# National Committee on Uniform Traffic Control Devices

Item No.: 20B-SIG-01

## NCUTCD Proposal for Changes to the Manual on Uniform Traffic Control Devices

**TECHNICAL COMMITTEE:** Signals Technical Committee  
**ITEM NUMBER:** 20B-SIG-01  
**TOPIC:** Accessible Pedestrian Pushbutton Locations  
**ORIGIN OF REQUEST:** Signals Technical Committee  
**AFFECTED SECTIONS OF MUTCD:** 4I-06 Pedestrian Detectors

**Figure 4I-X. Pushbutton Location Area**

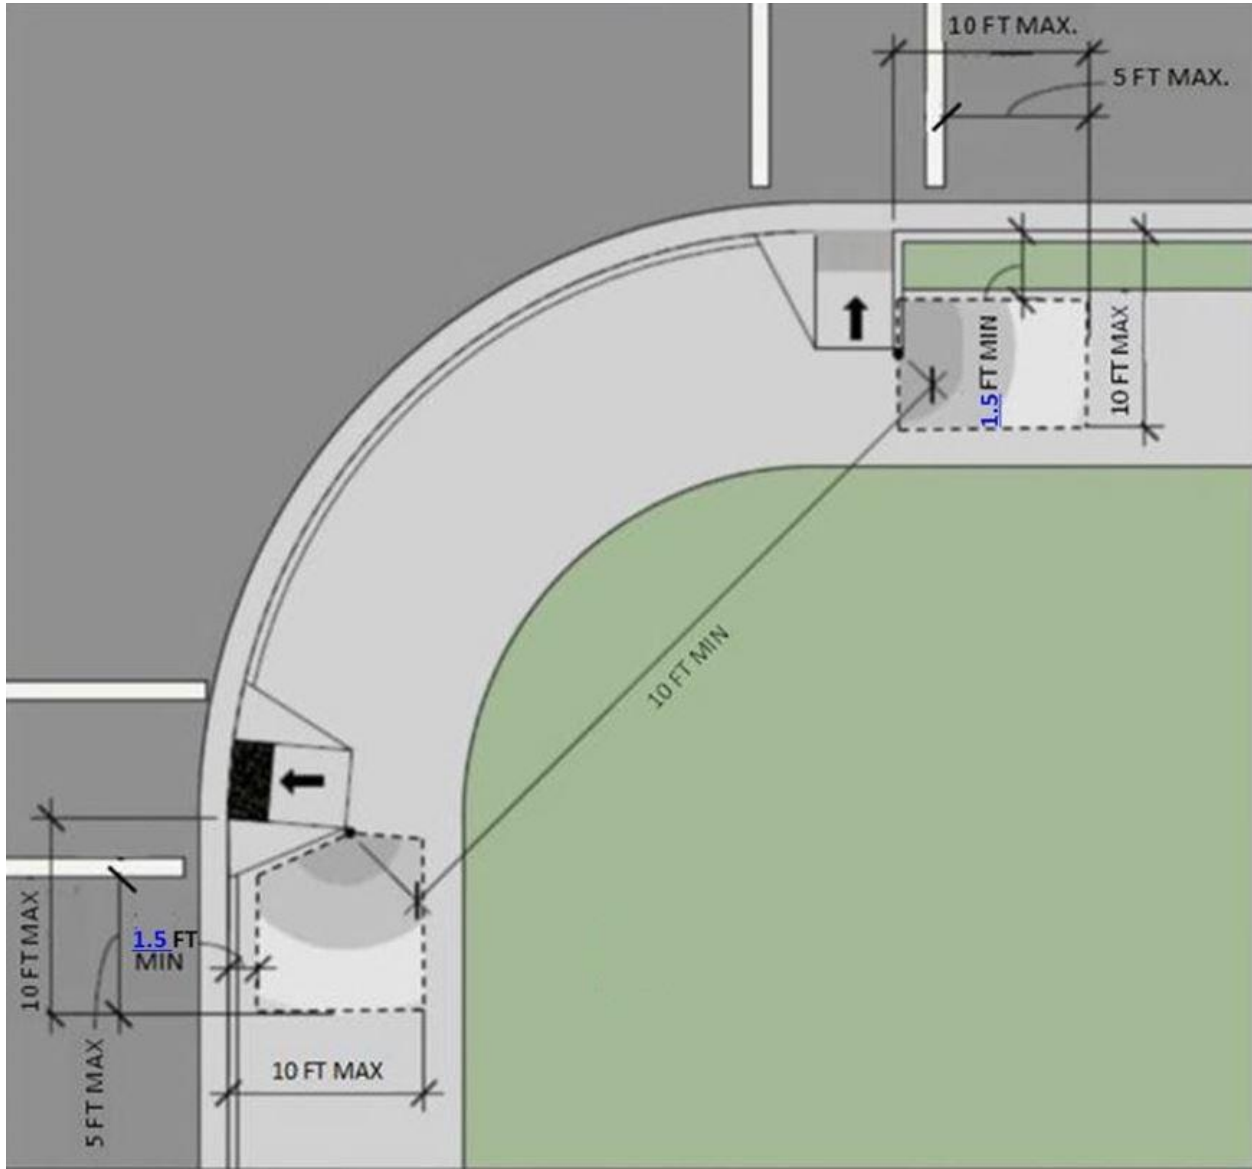
41 2. **Revision Figure 4I-X:** When the revisions were approved to Figure 4I-X at the January  
42 2020 National Committee meeting, the minimum distance between the pedestrian  
43 pushbutton and curb was incorrect. The figure showed a minimum distance of 1-foot, yet  
44 the text in Section 4I-06 Guidance clearly indicates the minimum distance is 1.5 feet  
45 which is compliant with the AASHTO clear zone requirements. This proposal changes  
46 the minimum distance from 1 foot to 1.5 feet to be consistent with existing MUTCD  
47 Guidance.

1. No greater than 5 feet from the outside edge of the marked crosswalk farthest from the intersection.
2. Not farther from the crosswalk than the stop line, if present.
3. Any maximum (MAX) or minimum (MIN) dimensions shown are based on Guidance Statements.
4. Two pedestrian pushbuttons on a corner should be separated by a minimum of 10 feet. The 10-foot dimension shown in this figure is in reference to the placement of the pushbuttons within their respective areas.
5. Figure ~~4I-4~~ ~~4E-4~~ shows typical pushbutton locations.

**Figure 4I-X. Pushbutton Location Area For Use Where A Single Ramp Exists Or Is The Only Available Alternative**

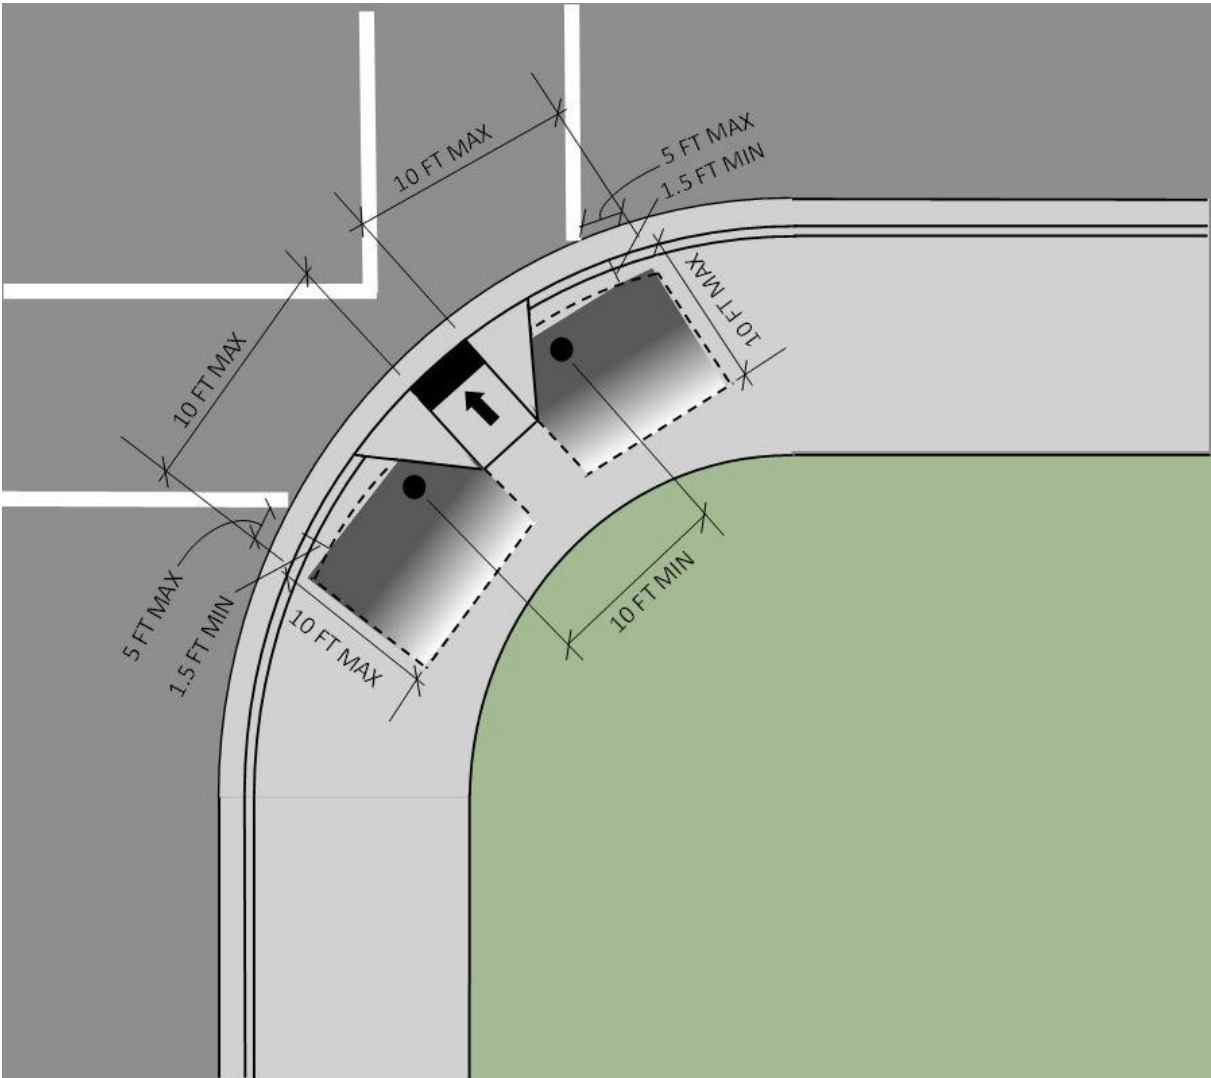
1. **Proposed Figure 4I-Y:** Very little guidance is provided for the placement of pedestrian detectors on street corners with a single pedestrian access ramp serving two crosswalks. The practice of using a single ramp to serve two crosswalks is not recommended because of the added complexities for pedestrians with disabilities. However, physical constraints frequently limit a corner to a single ramp. Positioning pedestrian detectors on corners with single access ramps is more challenging than on corners with two ramps because single ramp corners do not allow optimum placement to accommodate all types of disabilities. The needs of vision impaired pedestrians are different than those of mobility

36 impaired pedestrians. The goal is to develop a design that, although not optimum, will  
37 work for all disabilities. A revised figure is proposed which would clarify proper  
38 placement of pedestrian detectors while allowing for defined flexibility and latitude,  
39 where necessary, to accommodate unique conditions for a given location. These  
40 revisions are shown in a new Figure 4I-Y.

- 1. This figure is shown for existing ramps or when conditions preclude the installation of two ramps on a corner
- 2. The pushbutton should not be farther than 5 feet from the outside edge of a marked crosswalk farthest from the center of the intersection, and not be farther from the curb ramp than the stop line, if present (Stop line not shown if figure)
- 3. Any maximum (MAX) or minimum (MIN) dimensions shown are based of Guidance Statements.
- 4. Two pedestrian pushbuttons on a corner should be separated by a minimum of 10 feet.
- 5. All dimensions referencing the curb are measured from the face of curb.
- 6. Figure 4E-4 shows typical pushbutton locations.
